H12124

DESCRIPTIVE REPORT

Descriptive Report to Accompany Hydrographic Survey H12124

Revisions Compiled During Office Processing and Certification

Figure 2. Difference between 2009 and 2010 seafloor

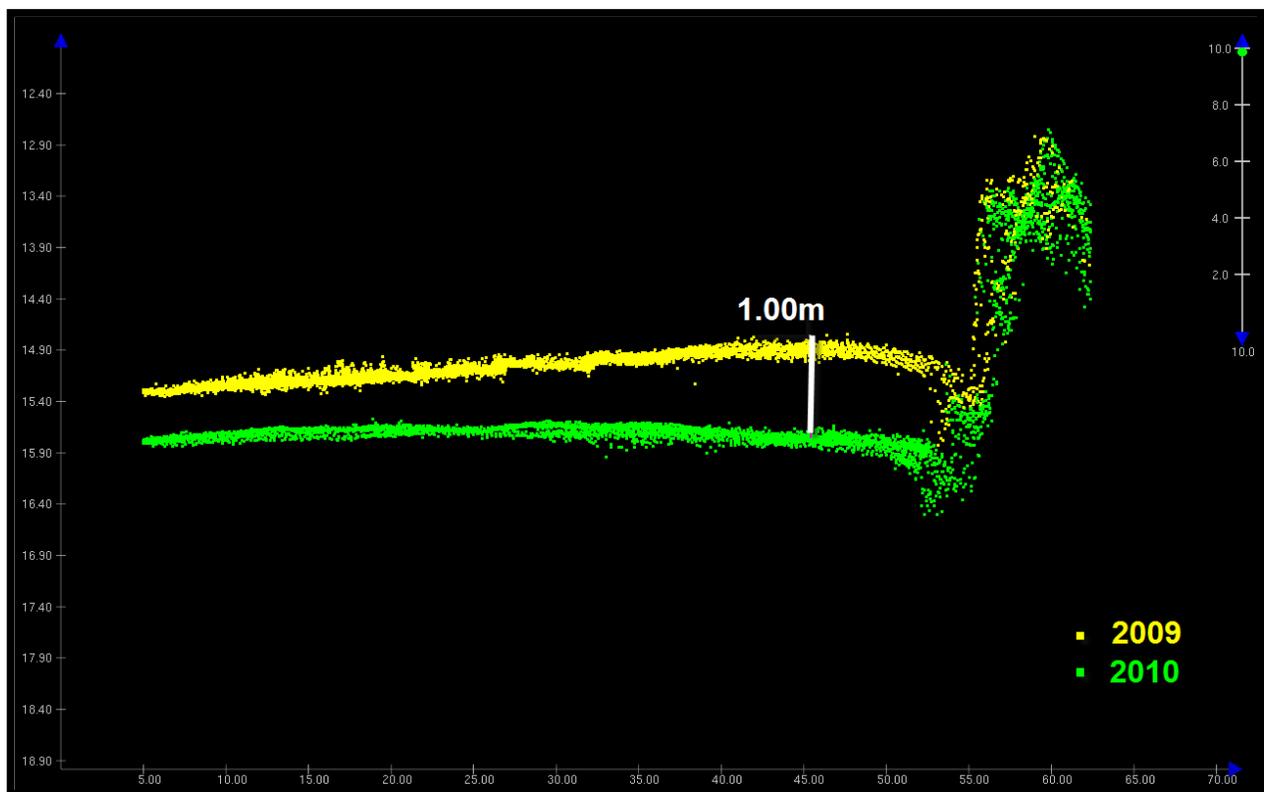
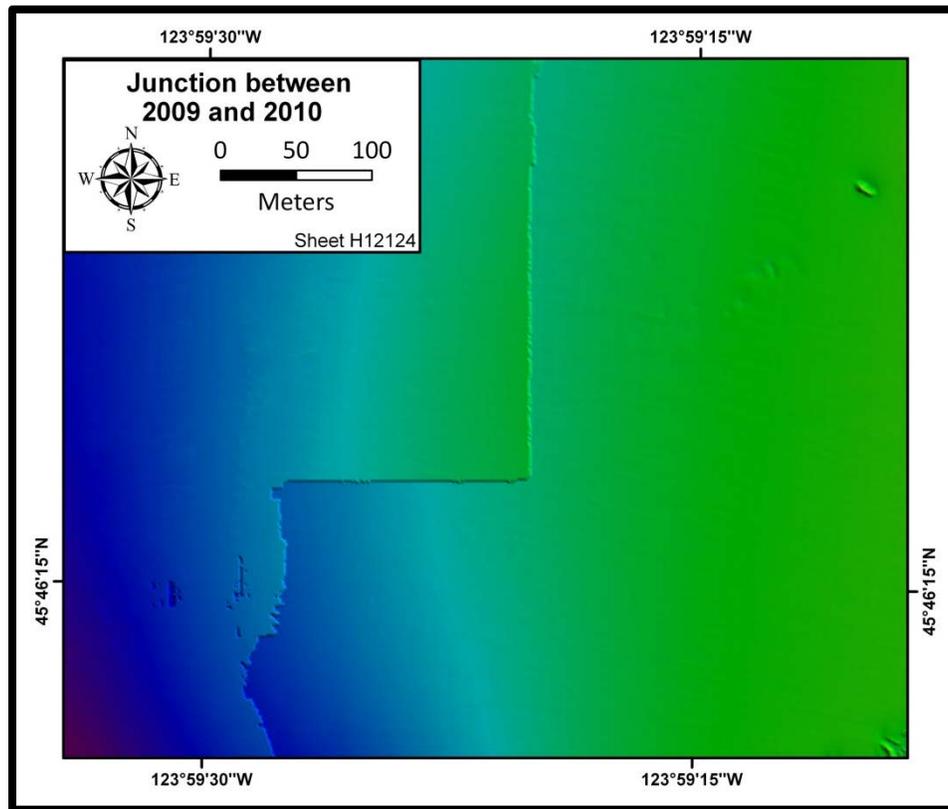
The 2009 and 2010 datasets exhibit differences of over 1 meter at their junction due to physical changes in the seafloor that occurred over the time frame between the two datasets. The datasets show good agreement over rocky areas, which is evidence of no systematic errors between the surveys, but do not agree in the sandy areas surrounding the rocks, as shown in Figures 2 and 3 below. These differences over the sandy bottom are attributable to sediment transport between the 2009 and 2010 collection efforts, and are representative of a true physical difference in the seafloor. As a result, nodes which fail due to high standard deviation at the junction between the datasets are considered within specification. To alleviate the effect of the year-to-year depth difference on the resulting CUBE surface, mainscheme data from each collection effort were trimmed along the primary junction to limit overlapping data in sandy areas.⁷ This provided a clear demarcation in the resulting CUBE surface between the 2009 and 2010 datasets.

- ⁶ Concur. Higher uncertainty is expected over steep terrain and slopes. The data is adequate for charting.
- ⁷ Concur with clarification. In areas of overlap between 2009 and 2010 data, the SAR review ensured deeper data were rejected and that least depth would be honored in the final combined surface from which H12124_SS.000 soundings are derived.

Figure 7. Depth discrepancies between H12124 and US3OR01M; Chart 18520 displayed

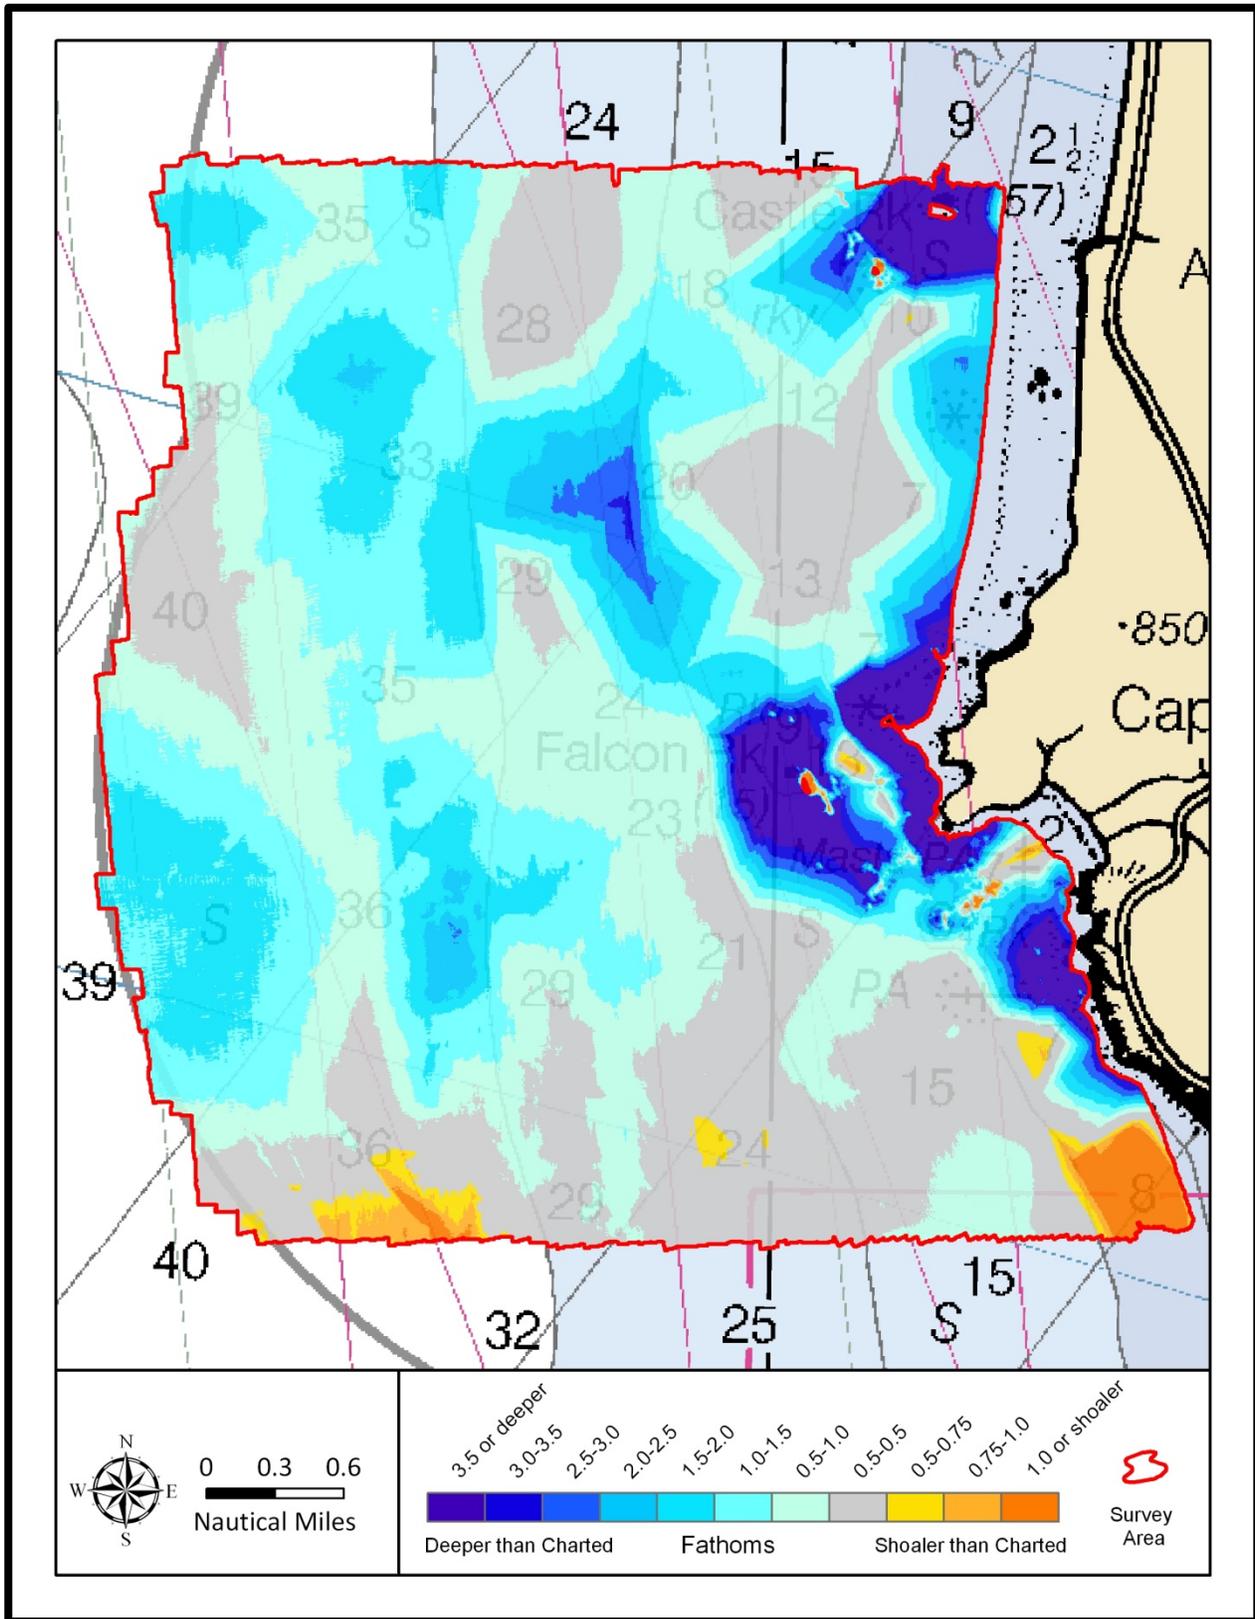
In general, survey H12124 depths are 1 to 2 fathoms deeper than those from the chart (Figure 7). The difference surface also shows areas of significant difference, from as much as 4 fathoms deeper to 3 fathoms shoaler. These more significant differences are mostly a byproduct of comparing a dense dataset to a surface produced from a triangulated irregular network (TIN) of a small scale ENC composed of sparse soundings and contours. Most of the significant variations occur in the vicinity of charted rocks where the surveyed seafloor is being compared to the interpolated surface. Given the scale of the underlying chart, most of these discrepancies are not considered navigationally significant.²⁰

1. There is shoaling of over three fathoms centered on the charted eight fathom sounding in the southeast corner of the survey area.²¹

- ¹⁹ Concur.
- ²⁰ Concur. Chart depth and features as depicted in the HCell.
- ²¹ Concur with clarification. A 5-fathom sounding replaces the charted 8 in H12124_CS.000.

Figure 8. Comparison of data to AWOIS #53809

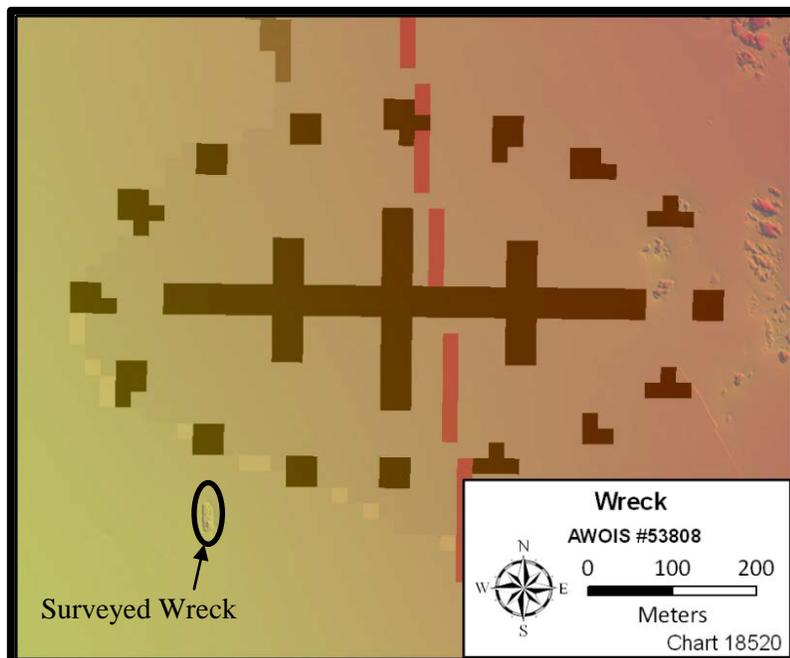
The search radius for AWOIS #53809 extends onto land (Figure 8). The survey vessel proceeded as far shoreward of the 4-meter contour as was safely possible and found no indication of the presence of a wreck. No exposed masts were visible to the survey vessel. AWOIS #53809 is considered disproved within the surveyed area.²³

- ²² Concur with clarification. A 5-fathom sounding replaces the charted 8 in H12124_CS.000.
- ²³ Do not concur. The full search radius was not achieved in the investigation. Retain the wreck.

Figure 10. Comparison of data to charted rock

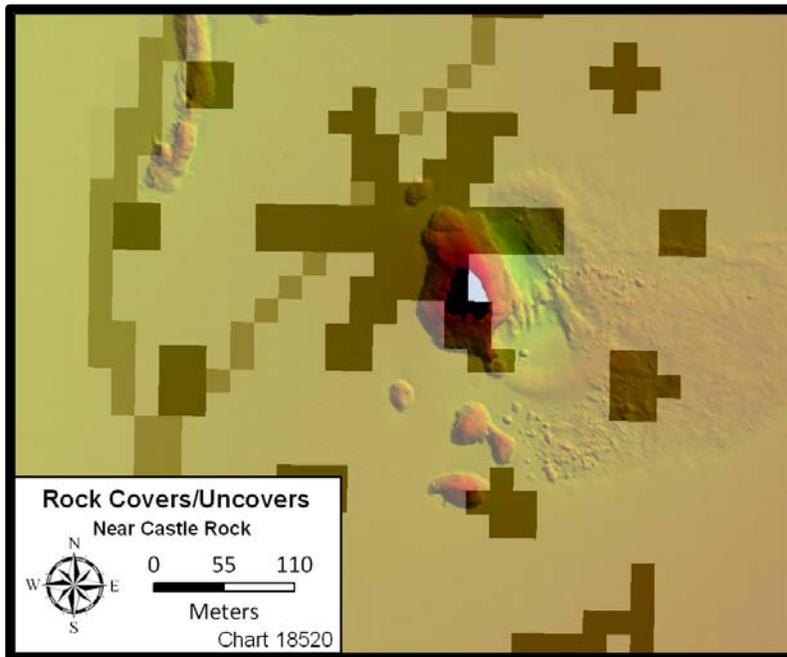
The charted and surveyed positions of the rock which covers and uncovers to the south-west of Castle Rock agree well (Figure 10). The center of the surveyed area lies 65 meters, or 0.4 millimeters at chart scale, to the south-east of the charted position. Due to the shift in the position of the rock, the ENC feature was disproved. The feature file includes an underwater rock feature which identifies the most shoal depth obtained around the base of this rock. The hydrographer recommends charting this rock as covers and uncovers and using the one meter BAG to estimate the geographic position of the rock.²⁵

- ²⁴ Concur. Updated wreck positioning is depicted in H12124_CS.000.
- ²⁵ Concur. Update rock position per H12124_CS.000.
- ²⁶ Concur. Chart per H12124_CS.000.

Figure 11. Comparison of data to charted rock

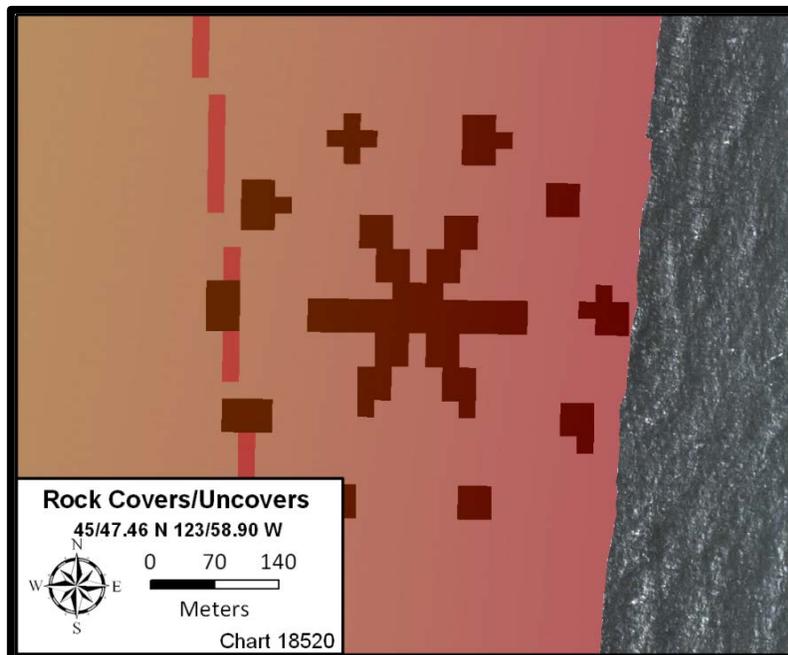
The charted rock which covers and uncovers approximately 1 nautical mile due south of Castle Rock, does not correlate to any rock within the surveyed dataset, or any rock observed by the field crew (Figure 11). The ENC feature is disproved within the surveyed area.²⁶

Figure 13. Comparison of data to Castle Rock

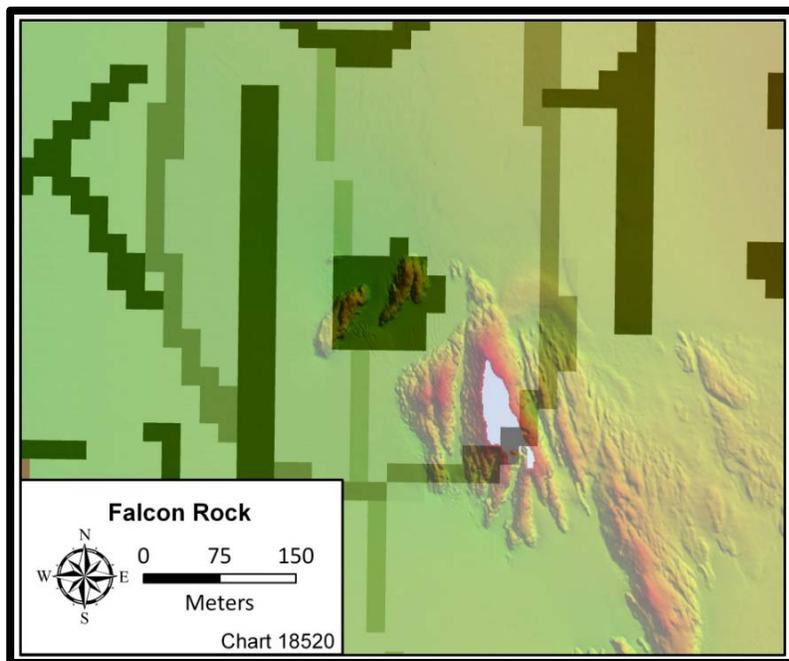
The charted and surveyed positions of Castle Rock agree well at chart scale (Figure 13). The surveyed position lies approximately 90 meters, or 0.5 millimeters at chart scale, to the south-south-east of the charted position. The hydrographer recommends adjusting the position of the land area to coincide with the survey data.³⁰

- ²⁹ Do not concur. Imagery is not sufficient for charting purposes. Retain landward rock as charted.
- ³⁰ Concur. Islet location was created based on hydrography; chart per H12124_CS.000.
